**World Forum for Harmonization of Vehicle Regulations****Working Party on Noise and Tyres****Seventy-ninth session**

**Tyres: UN Regulation No. 117 (Tyre rolling resistance, rolling noise and wet grip)****Proposal for Supplement 2 to the 03 series of amendments to  
UN Regulation No. 117****Submitted by the experts from the European Tyre and Rim Technical  
Organization\***

Figure 1  
**Minimum requirements for test surface area. The shaded part is called "Test area"**

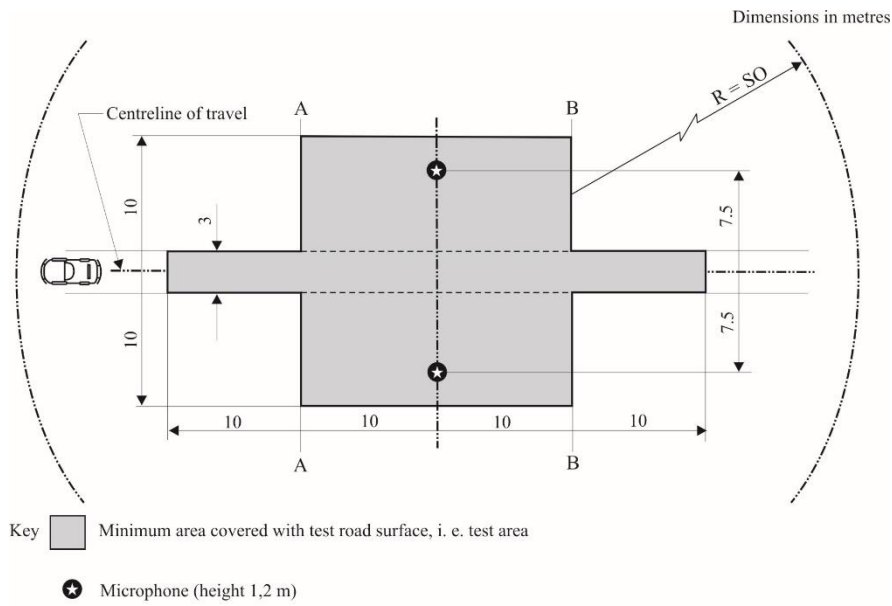
~~When designing the test track layout it is important to ensure that, as a minimum requirement, the area traversed by the vehicles running through the test strip is covered with the specified test material with suitable margins for safe and practical driving. This will require that the width of the track is at least 3 m and the length of the track extends beyond lines AA and BB by at least 10 m at either end. Figure 1 shows a plan of a suitable test site and indicates the minimum area which shall be machine laid and machine compacted with the specified test surface material. According to Annex 3, paragraph 3.2., measurements have to be made on each side of the vehicle. This can be made either by measuring with two microphone locations (one on each side of the track) and driving in one direction, or measuring with a microphone only on one side of the track but driving the vehicle in two directions. If the latter method is used, then there are no surface requirements on that side of the track where there is no microphone.~~

~~For the purpose of this measurement, cores have to be taken from the track in at least four different positions, which are equally distributed in the test area between lines AA and BB (see Figure 1). In order to avoid inhomogeneity and unevenness in the wheel tracks, cores should not be taken in wheel tracks themselves, but close to them. Two cores (minimum) should be taken close to the wheel tracks and one core (minimum) should be taken approximately midway between the wheel tracks and each microphone location.~~

Figure 2  
**Grading curve of the aggregate in the asphaltic mix with tolerances**

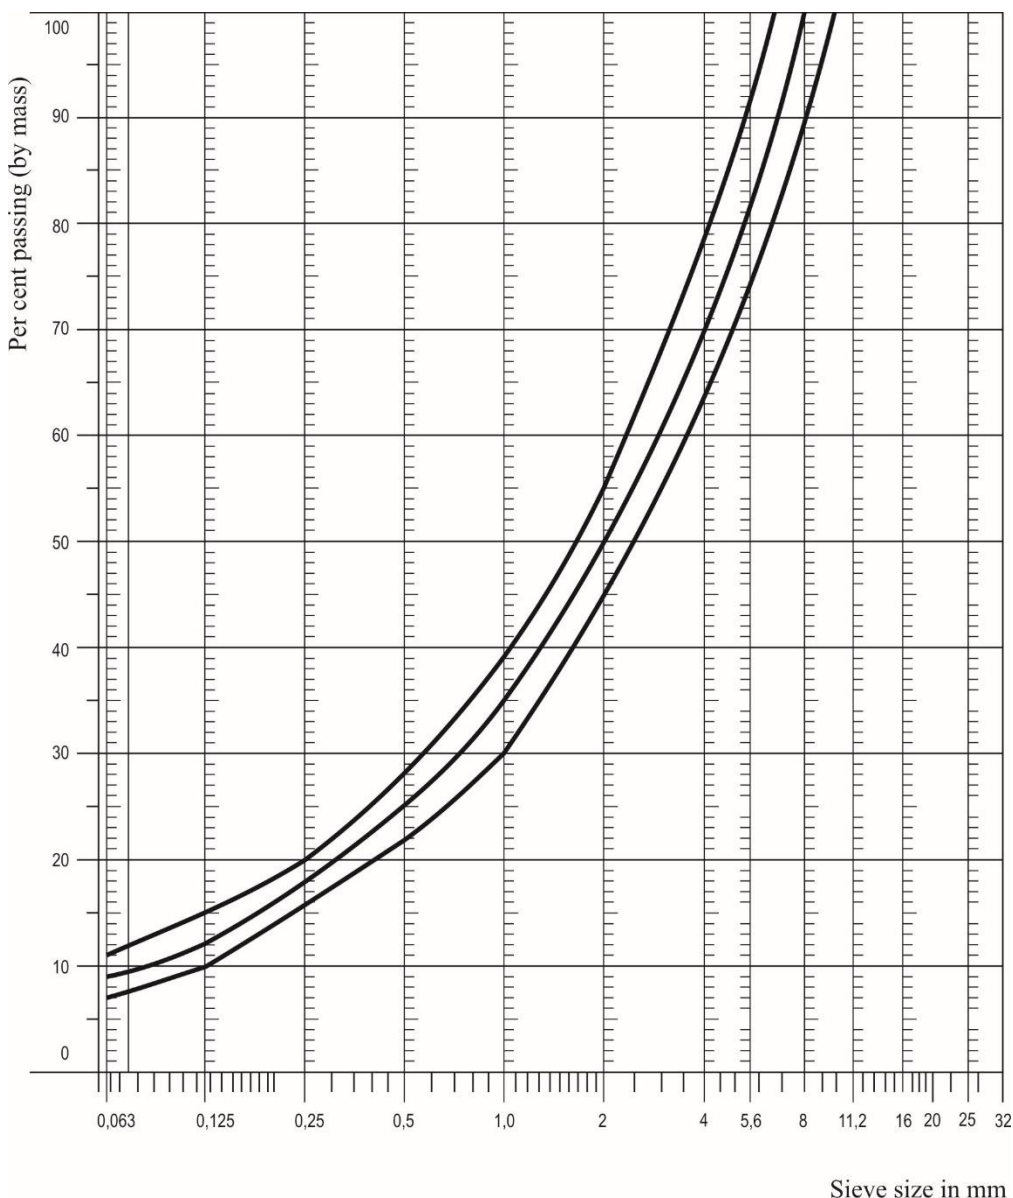
As a guide to the surface constructor, an aggregate grading curve which will give desired characteristics is shown in Figure 2. In addition, Table 1 gives some guidelines in order to obtain the desired texture and durability. The grading curve fits the following formula:

- (g) ~~The temperature of the mix before rolling shall be chosen so as to achieve by subsequent rolling the required voids content. In order to increase the probability of satisfying the specifications of paragraphs 2.1. to 2.4. above, the compactness shall be studied not only by an appropriate choice of mixing temperature, but also by an appropriate number of passings and by the choice of compacting vehicle.~~
